Subject: Oconee Nuclear Station  
Docket Nos. 50-269, -270, -287  
Response to Request for Additional Information on  
the Oconee Emergency Power System

REQUEST FOR ADDITIONAL INFORMATION  
OCONEE EMERGENCY ELECTRICAL POWER  
DISTRIBUTION SYSTEM

Keowee Data From Test 3

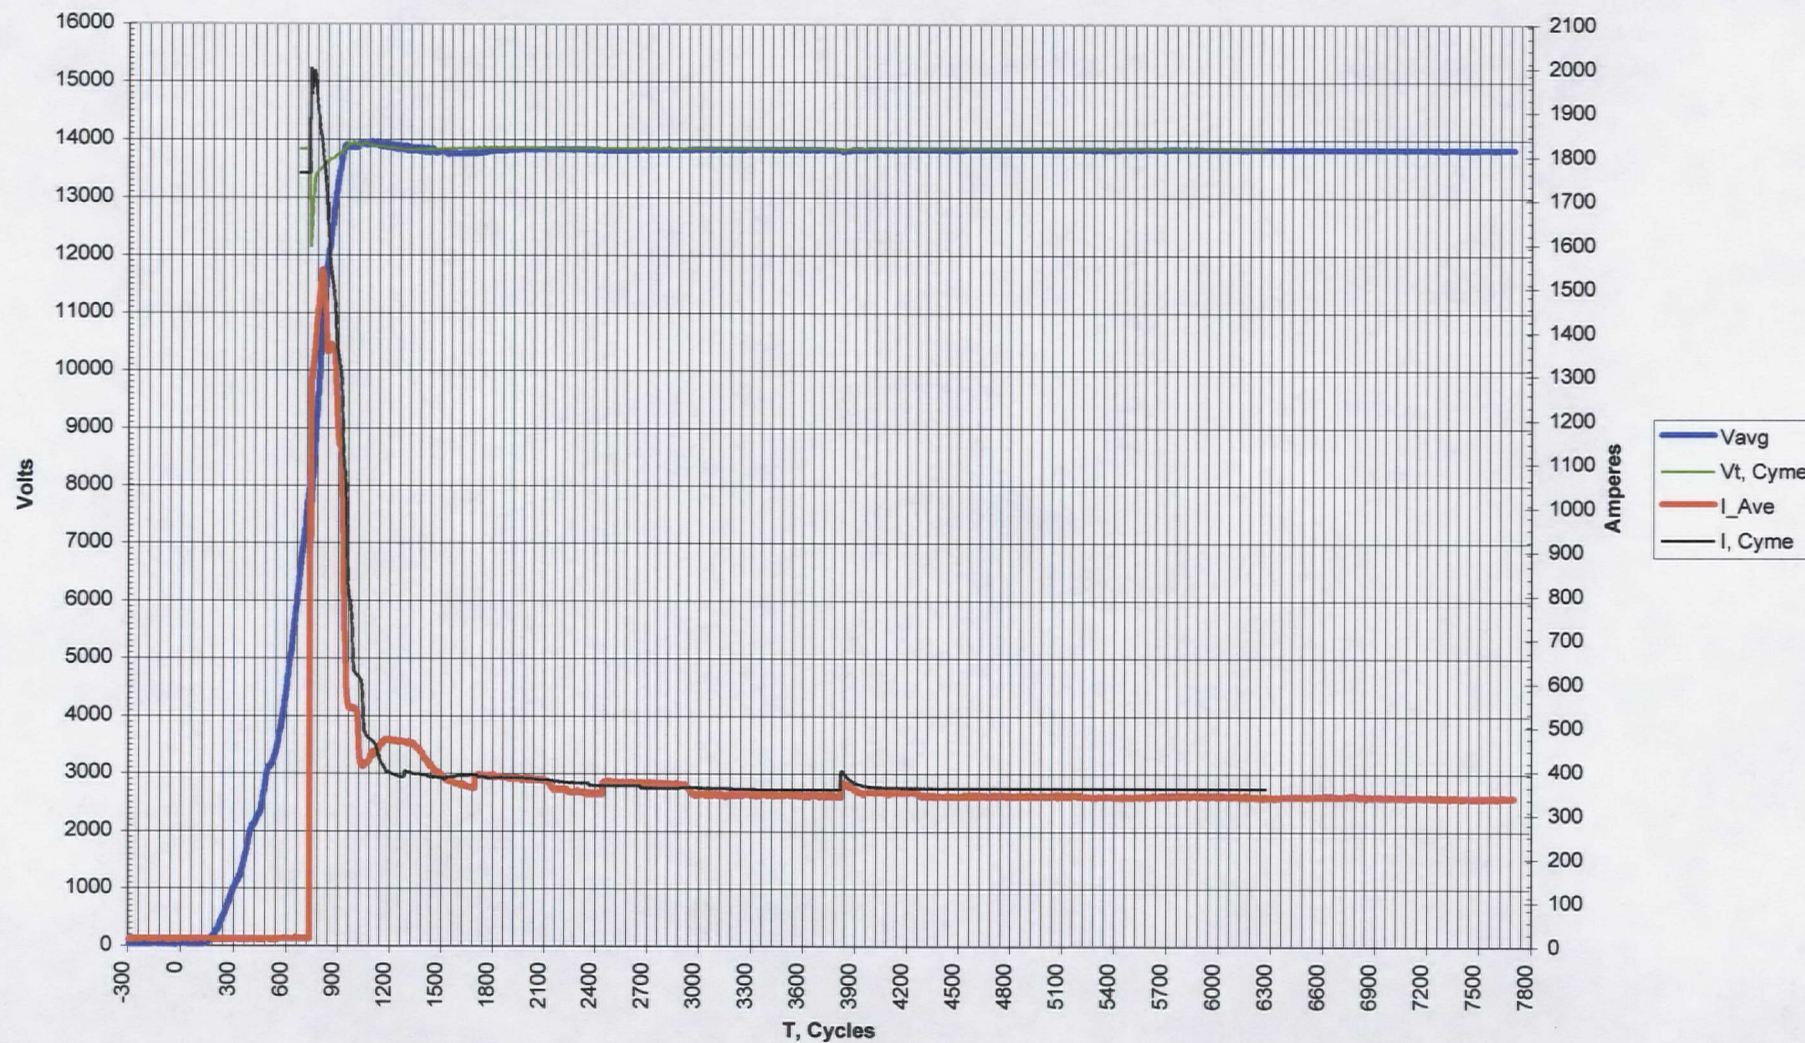
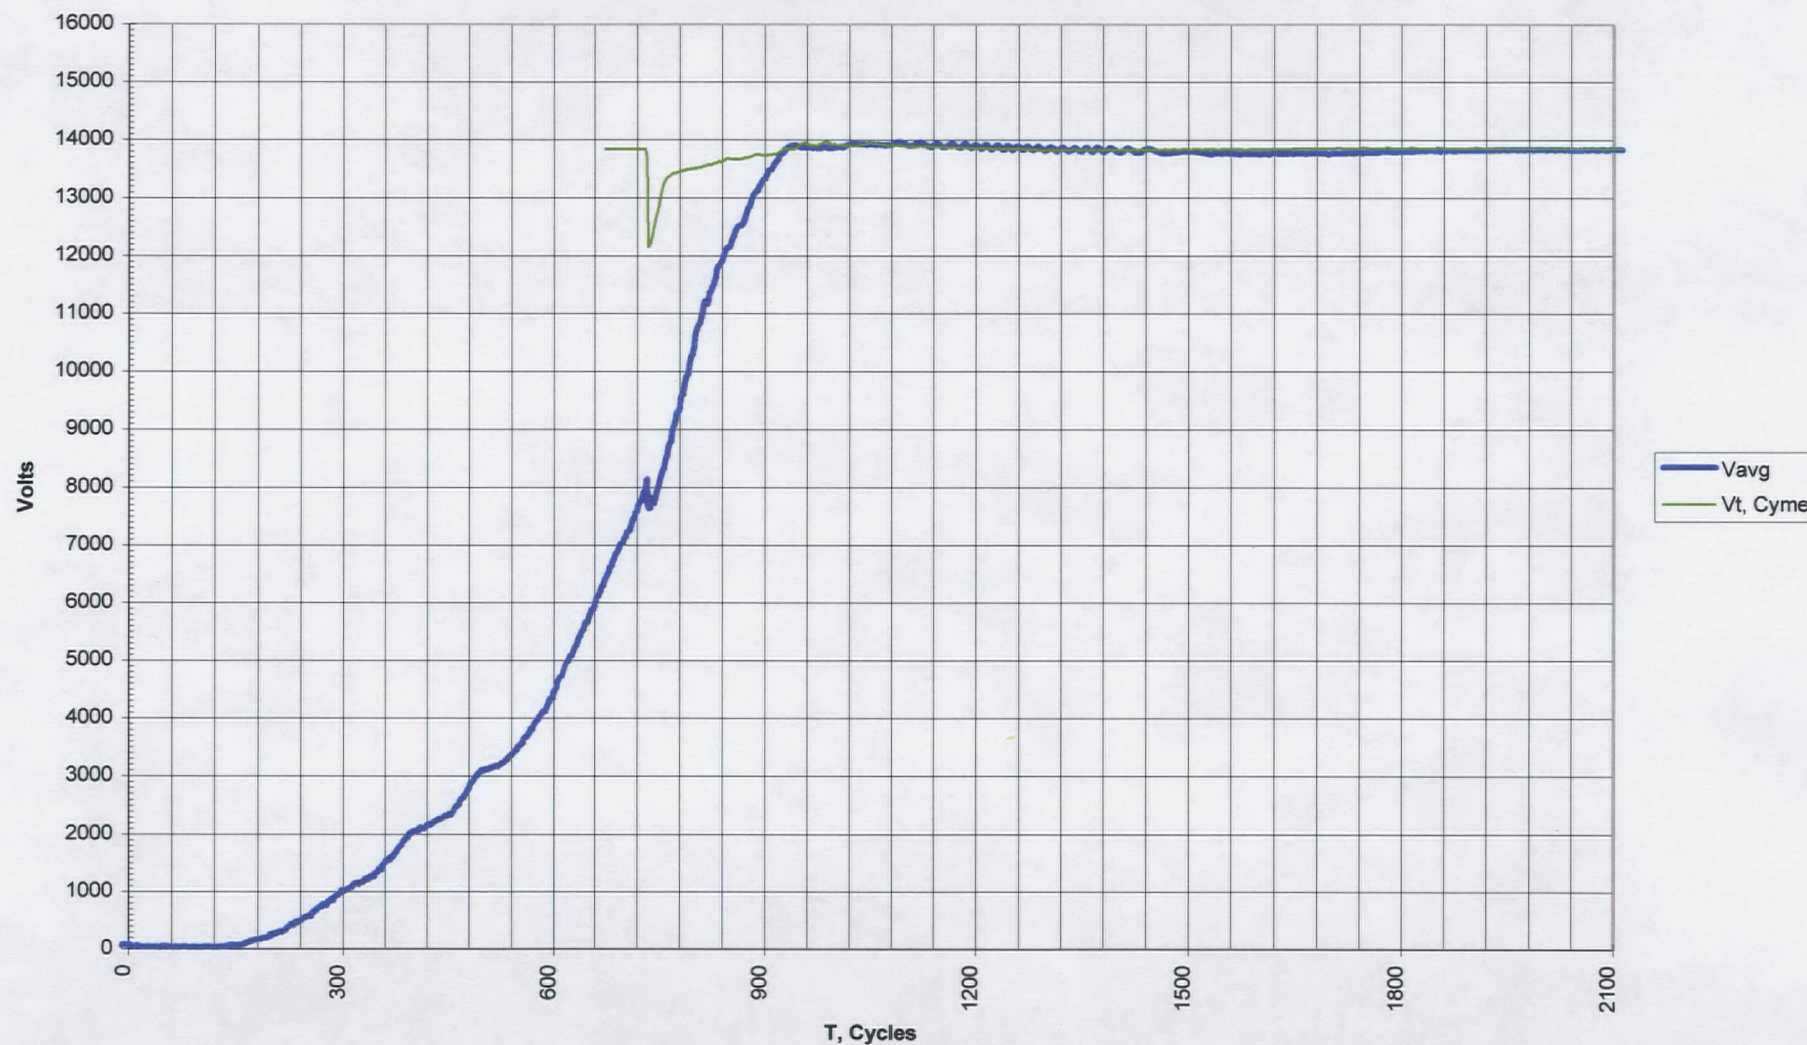
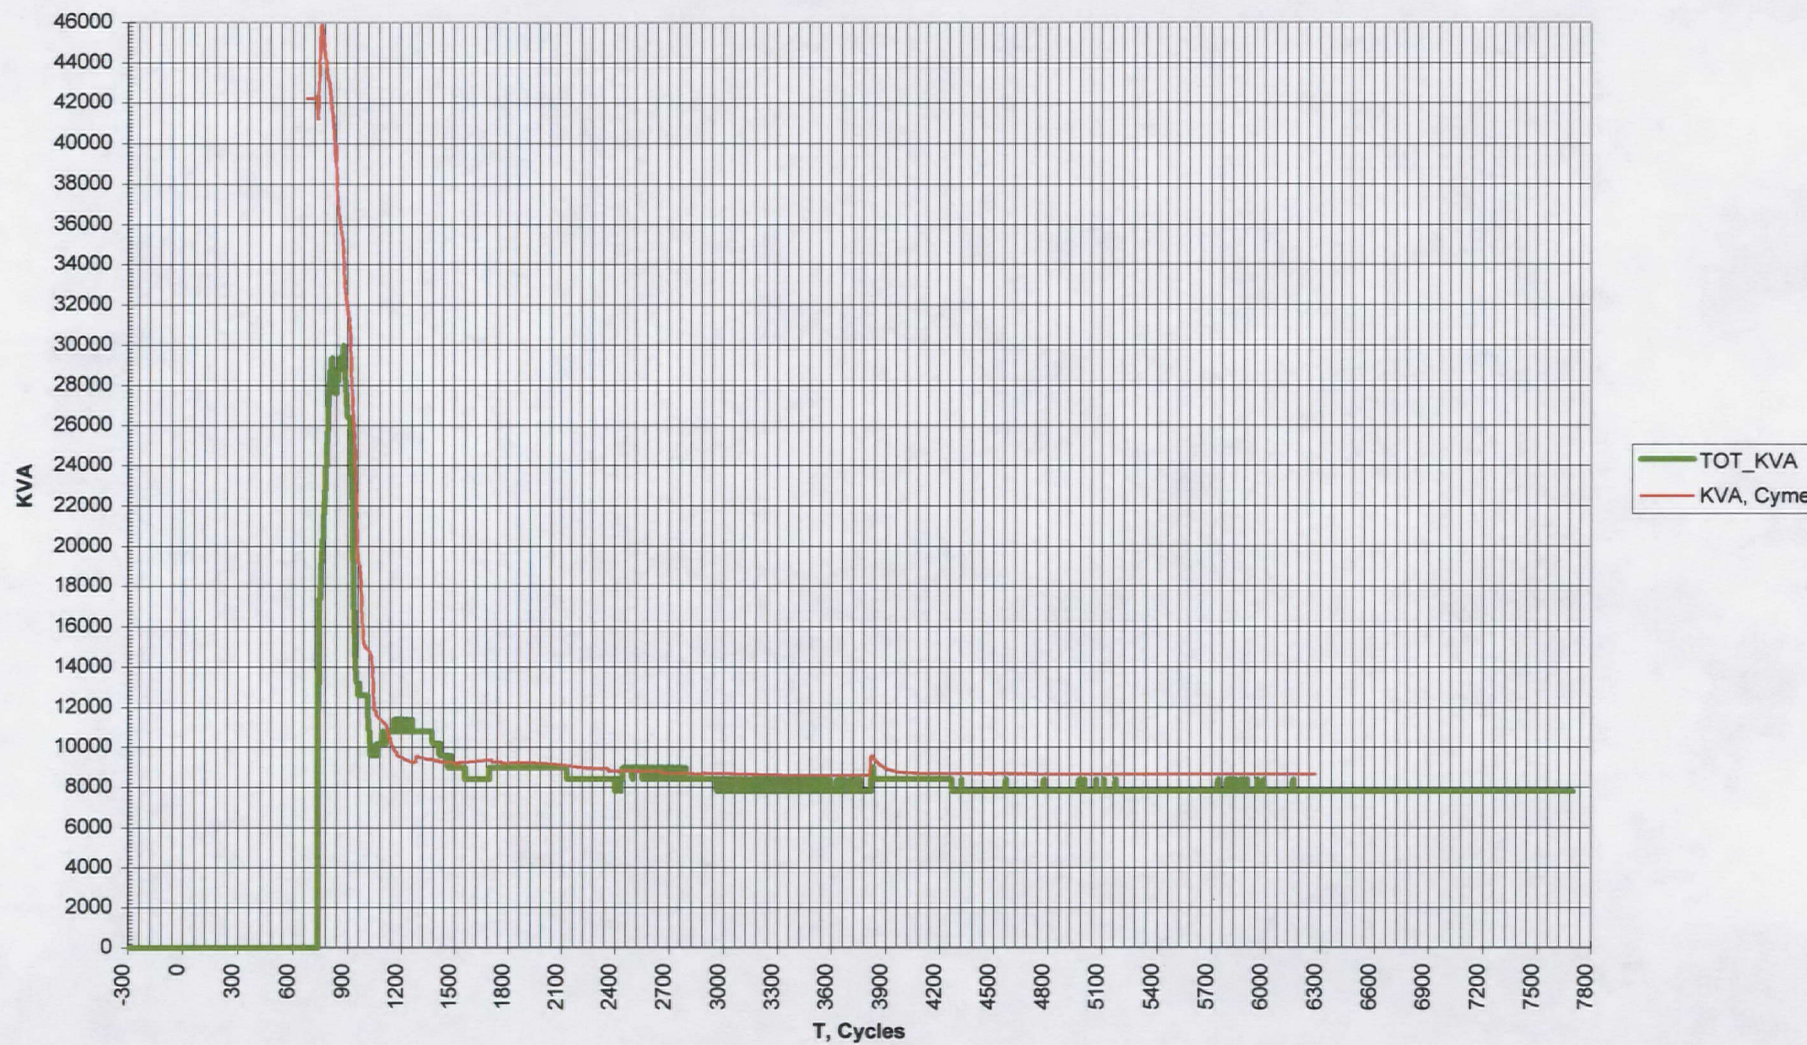
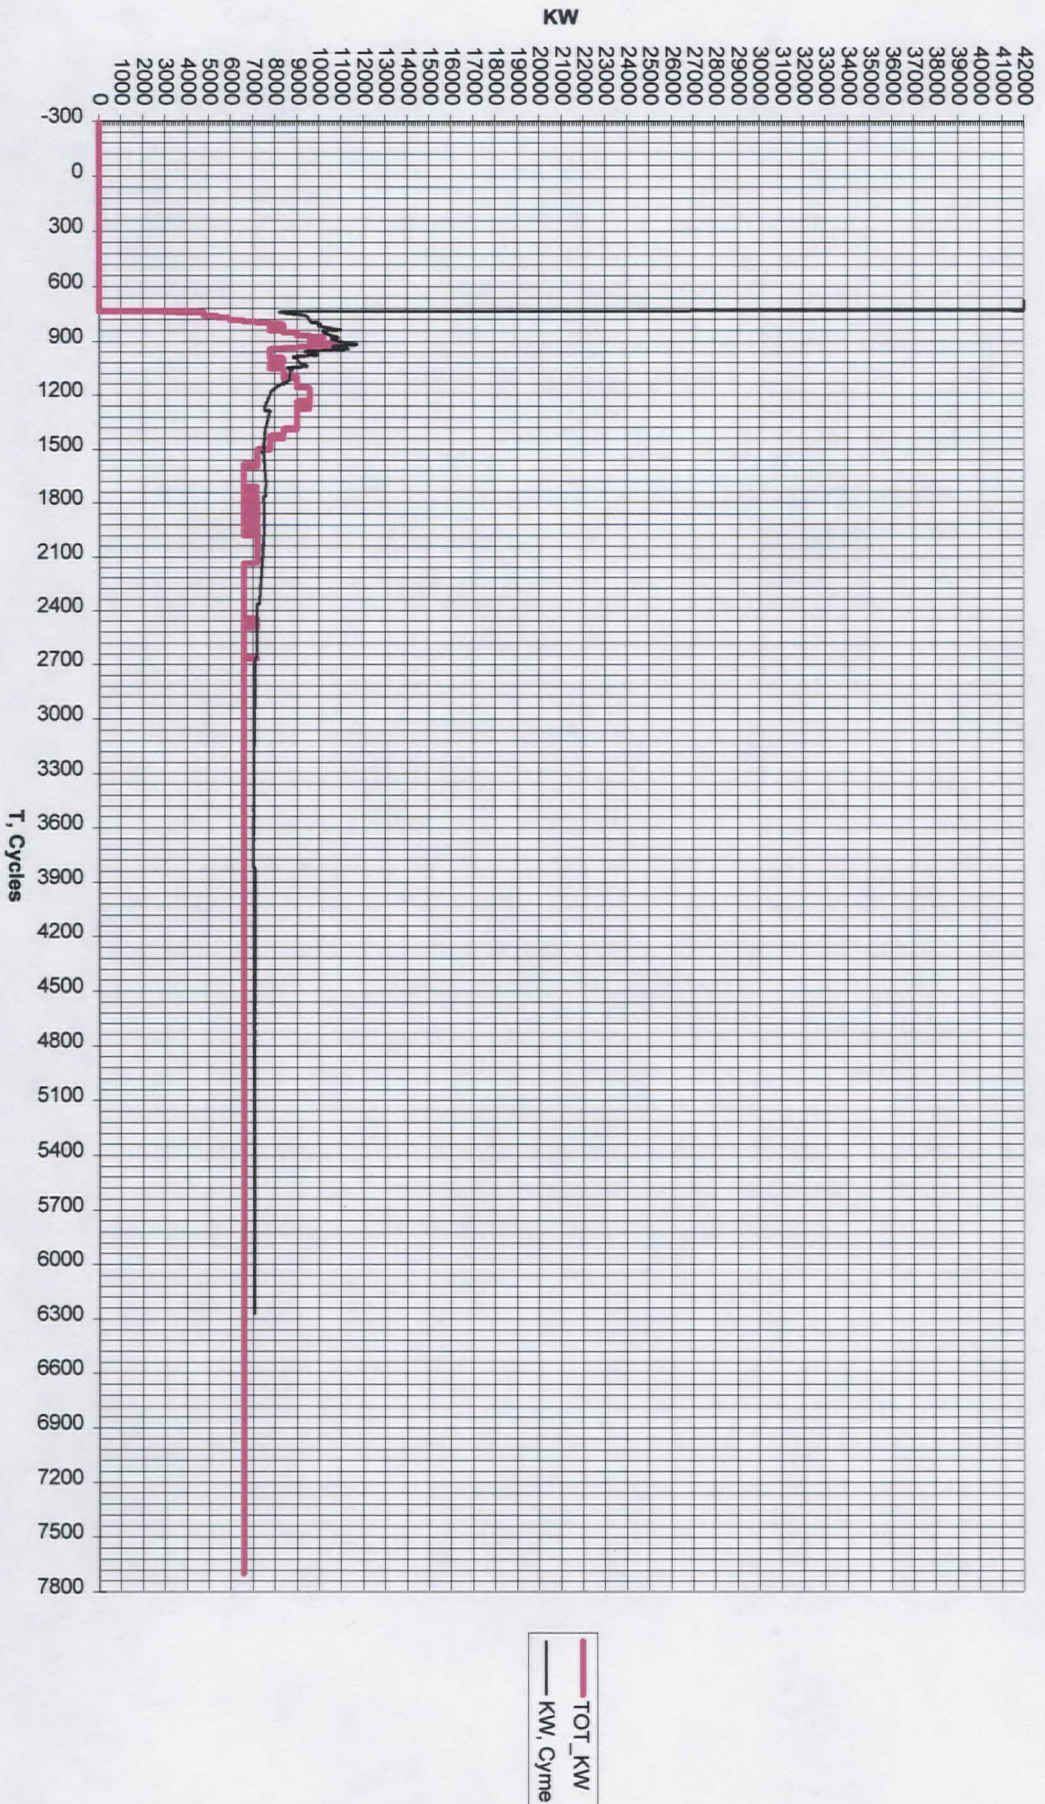
7. The conclusion of the report states that although Test 3 (reduced voltage and frequency starting scenarios) is not included in this report, a comparison of the test data and CYME model predictions show the model to predict conservative results, except for the RBCF B motor.

- a. If the CYME program cannot begin its analysis at a frequency different from 60 Hz, how was the program used to make this prediction?

Although the CYME program cannot directly be used to perform analyses with the Keowee unit starting from standby, it is used to predict the response of the Oconee loads indirectly. An analysis/comparison was performed for Test 3 assuming a small load rejection which gave an overspeed response similar to that seen during Test 3. Loading was applied in the model at load rejection. Since in the model loads will be starting entirely during the overspeed, the model will be conservative relative to the actual start from standby (i.e., rotating equipment load torque varies approximately as the square of the frequency and motor torque capability varies

approximately inversely with the square of the frequency). Figures H-1 through H-6 in Attachment 8 are a comparison of the model response and the Test 3 response. Similar comparisons of motor acceleration times indicate conservative motor start times (except for the RBCF which requires an adjustment for reverse rotation as previously identified in the report).
